DRAFT
Environmental Impact Statement

Appendix 17B

Supplemental PCN Information

The Belleayre Resort at Catskill Park

Project 00052
Date 12/11/02
CAD # 0052WILD
Drawing
MP-1

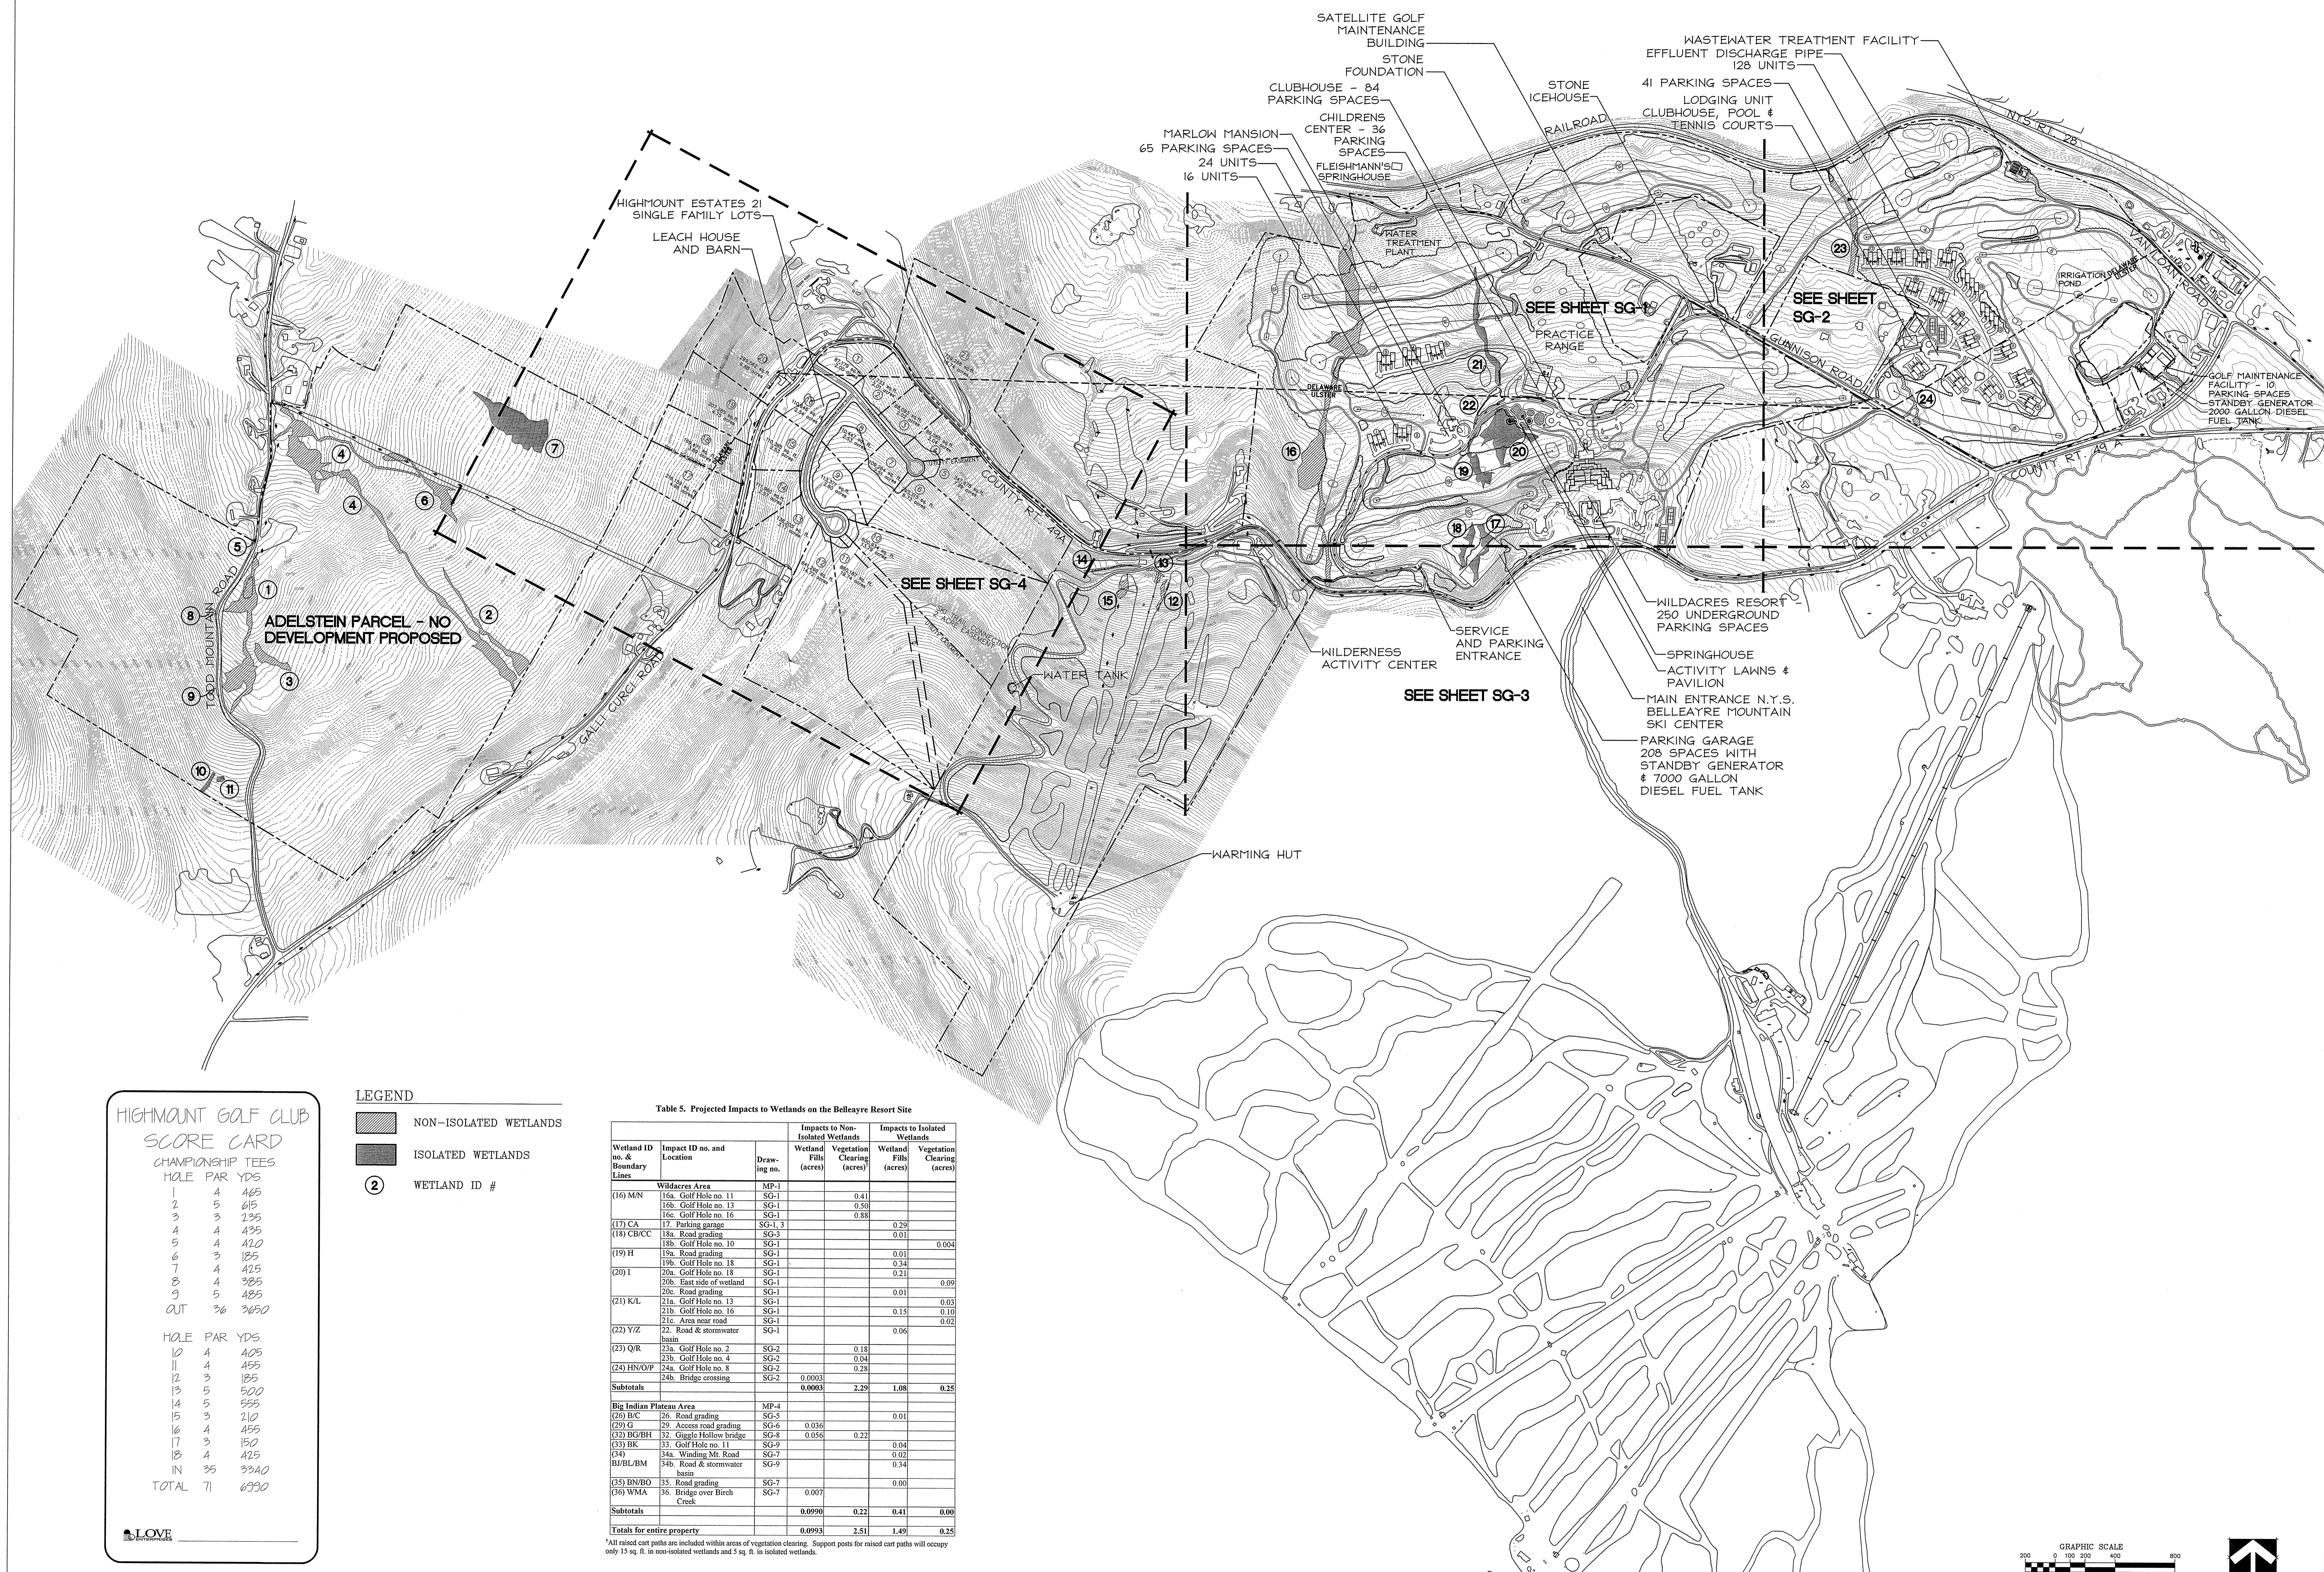
Since we last submitted information to you a new surface outfall option has been designed for the wastewater treatment plant at Wildacres (See Sheet MP-1 and Figure 18 on Detail Sheet D-3). Like the Big Indian Plateau wastewater treatment plant outfall, all activities for the Wildacres wastewater treatment plant outfall are proposed above the ordinary high water mark and outside of the wetlands. There are no wetlands between the treatment plant and the outfall location that would require utility line crossings.

Also, although the impacts to regulated wetlands are truly minimal being far less than 0.1 acres, the applicant has proposed to preserve 6.09 acres of wetlands on the Adelstein parcel (See drawing MP-1). These wetlands are, moreover, surrounded by substantial upland acreage that will eventually be protected as well, if and when the overall project is approved as part of the extensive state environmental review process. For purposes of this PCN, however, the preservation of the stream corridors and upland buffer, as well as the wetlands, as described above and in the original submission is a more than substantial and sufficient offer of compensatory mitigation.

Stream Corridor and Wetland Preservation. The proposed stream corridor and wetland preservation areas are shown on revised Sheets MP-1 and MP-4 that are enclosed. Also included on Sheets MP-1 and MP-4 is a note in the legend of how the preservation areas are to be protected by a filed deed restriction that will ensure no further development, i.e. construction of structures or grading, in those areas but instead their preservation for wildlife and passive recreational opportunities.

LASHER ROAD EMPLOYEE PARKING LOT

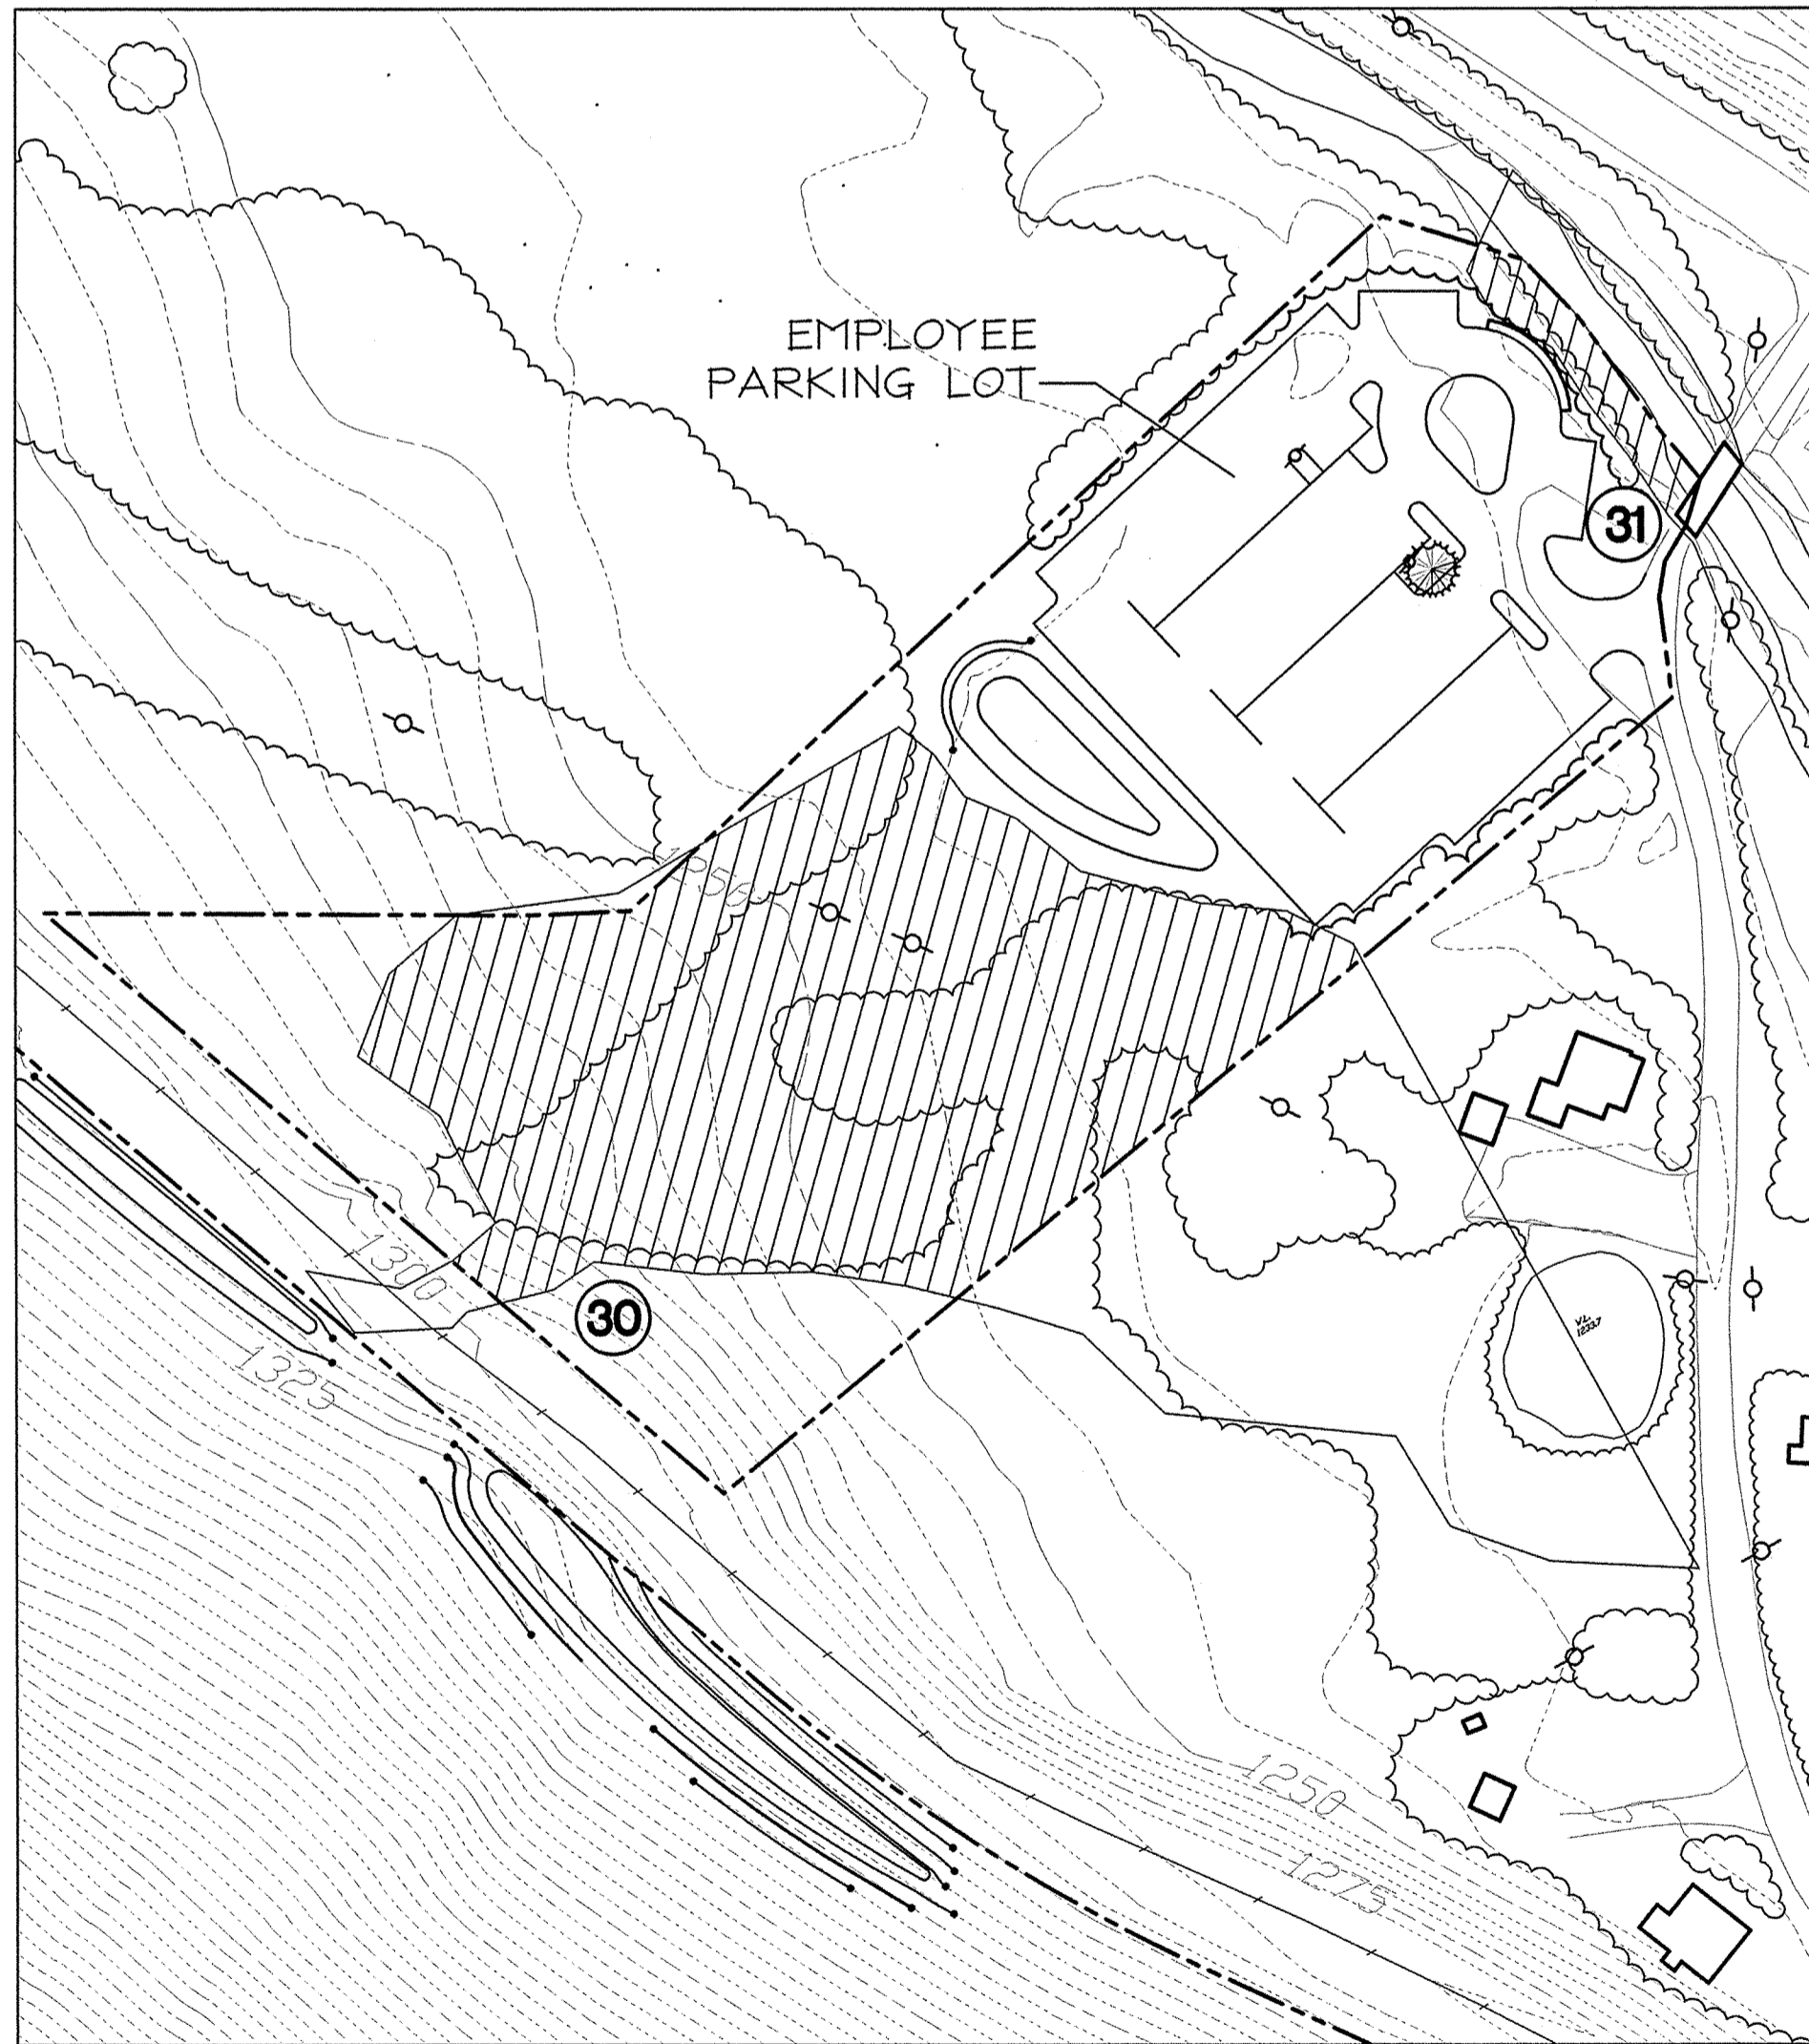
A 100 scale drawing of the employee parking lot off of Lasher Road is included as an insert on Sheet SG-10. The plan shows that no grading is proposed within waters of the US, including no grading within wetlands for construction the parking lot and its stormwater detention basin.
